PHY High Level Block Diagrams – R02

16 October 2013

Avi Kliger, Mark Laubach
Broadcom

EPoC Downstream **CLT** Transmitter Block Diagram

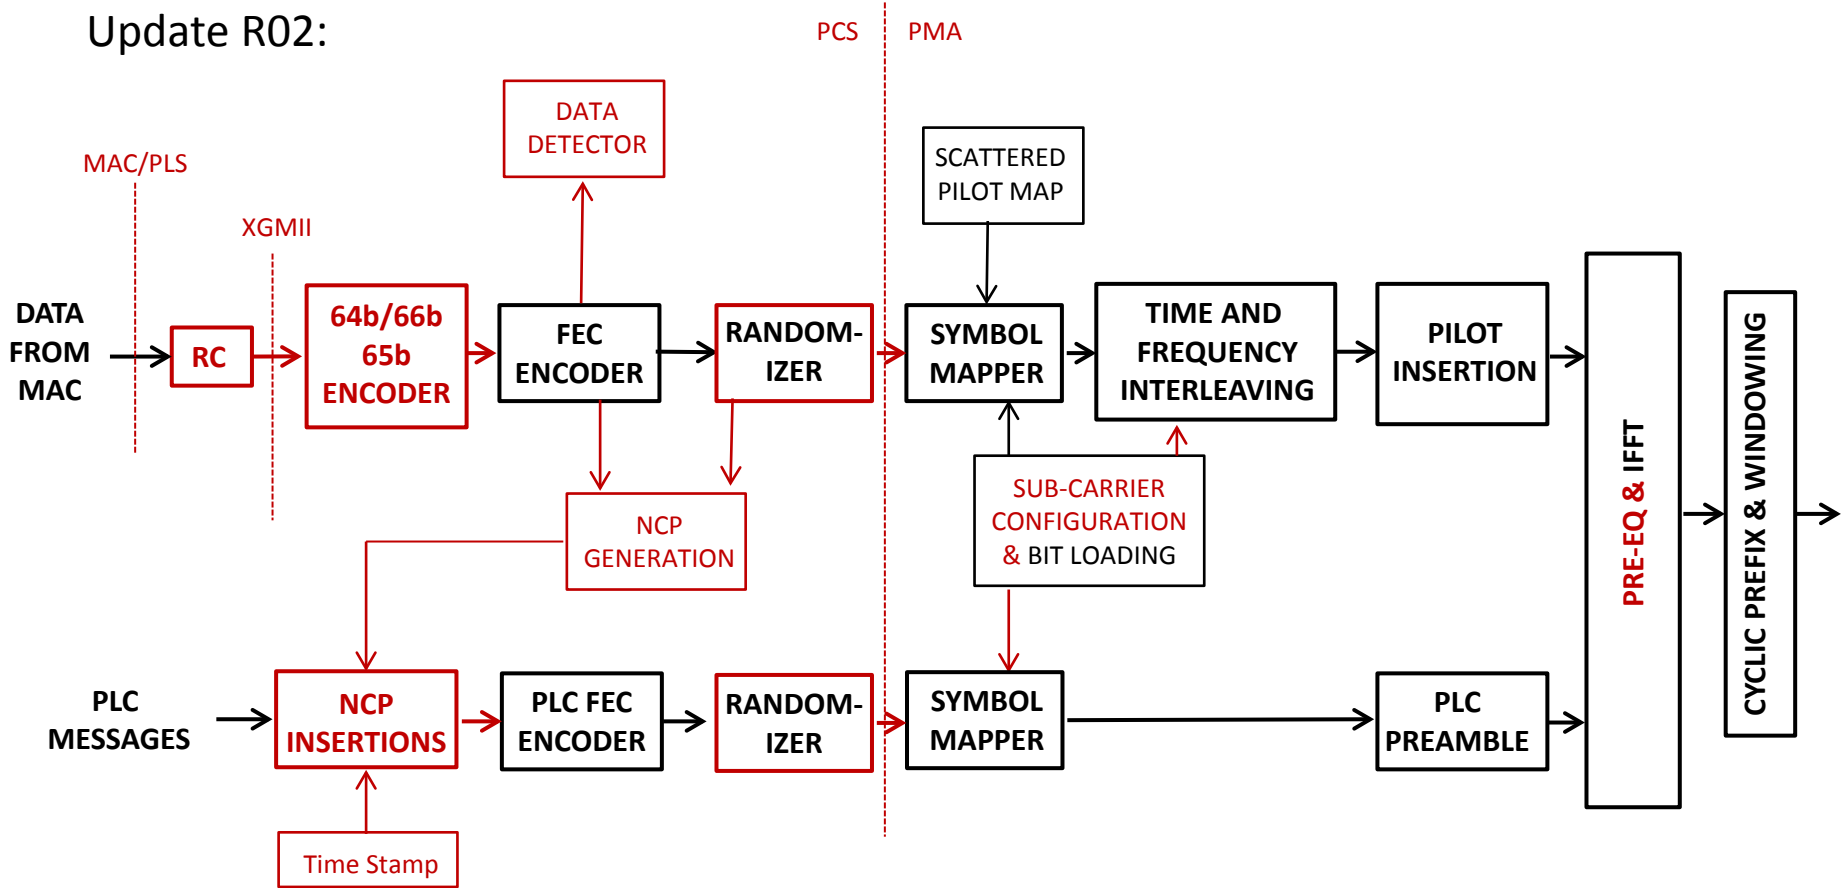
Previous (old original):

EPoC Downstream Transmitter Block Diagram (starting point)

Update R02:

NOTE: Sub-Carrier Configuration includes sub-carrier use and QAM mapping

NOTE: Not converted yet to IEEE 802 Vertical Form

EPoC Upstream CNU Transmitter Block Diagram

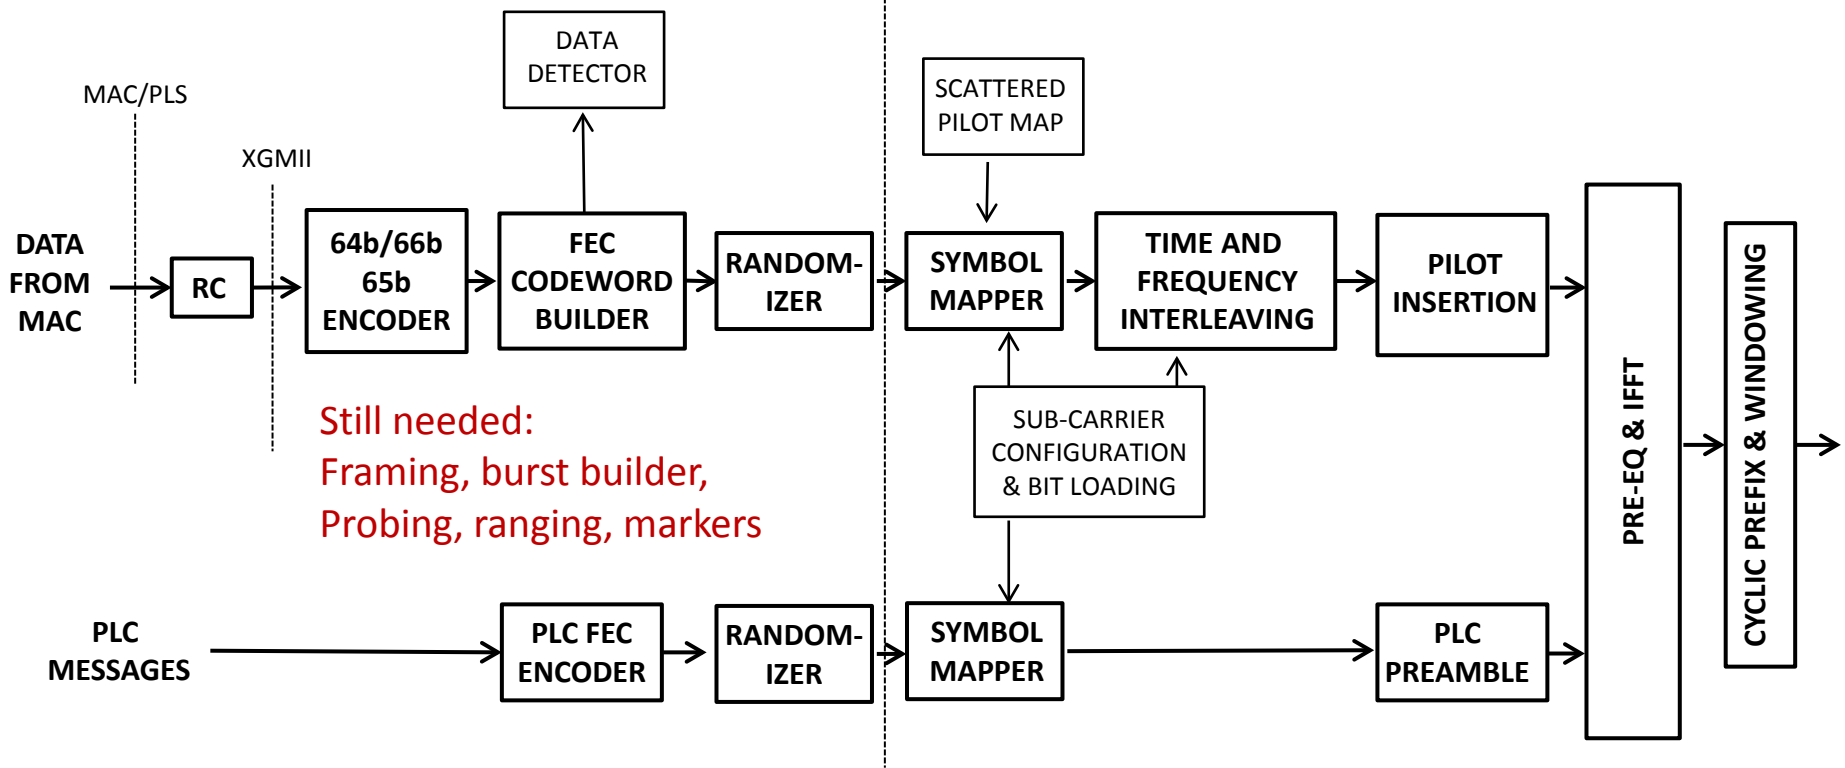
All New R02 (in progress):

Still needed:
Framing, burst builder,
Probing, ranging, markers

Assumption: Upstream PLC will be similar to downstream, with added functionality to control bursts separate from data

NOTE: Sub-Carrier Configuration includes sub-carrier use and QAM mapping

NOTE: Not converted yet to IEEE 802 Vertical Form
